# Access Compliance Report

## Public Rights-of-Way

Intersection ID: 42593	Main Street: W_MOREHEAD_ST	Cross Street: W_JOHN_BELK_RA	Location:	N
ADA ID: 24365EDF0063	Ramp Type: Perp	Initial Pass/Fail: Fail	Overall Compliance: No	Severity Score: 12.5
Codes/Mitigation Info/Possible Solution		Field Measurements/Component Compliance

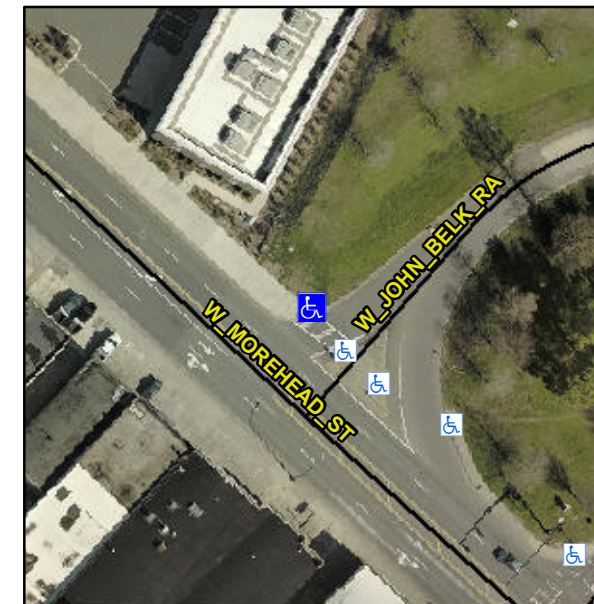
**Not Found, R304.5.3**

Compliance	Description	Data	Compliance	Description	Data
N/A	Ramp Length (in)	46.0	Yes	Ramp Slope (%)	5.1
Yes	Ramp Width (in)	96.0	No	Ramp XSlope (%)	6.0
N/A	Flare Type LT	N/A	N/A	Flare Type RT	N/A
N/A	Flare Slope LT (%)	N/A	N/A	Flare Slope RT (%)	N/A
N/A	Flare Traversable LT?	N/A	N/A	Flare Traversable RT?	N/A
N/A	Landing Length (in)	N/A	N/A	DWS Provided?	N/A
N/A	Landing Width (in)	N/A	N/A	DWS Contrast?	N/A
N/A	Landing Slope (%)	N/A	N/A	DWS Length (in)	N/A
N/A	Landing X Slope (%)	N/A	N/A	DWS Full Width?	N/A
N/A	Landing Curb? (Y/N)	N/A	N/A	DWS Offset (in)	N/A
N/A	Shared Landing?	N/A			
N/A	Gutter Ponding?	N/A	N/A	Gutter Slope (%)	N/A
N/A	Gutter Lip Ht (in)	N/A	N/A	Gutter X Slope (%)	N/A
N/A	Painted X Walk1?	Yes	N/A	Painted X Walk2?	N/A
	X Walk 1 Direction	To SE		X Walk 2 Direction	N/A
N/A	X Walk 1 Width (in)	117.0	N/A	X Walk 2 Width (in)	N/A
	X Walk 1 Slope (%)	7.0		X Walk 2 Slope (%)	N/A
	X Walk 1 X Slope (%)	4.3		X Walk 2 X Slope (%)	N/A

**Remove & Replace Entire Ramp.**
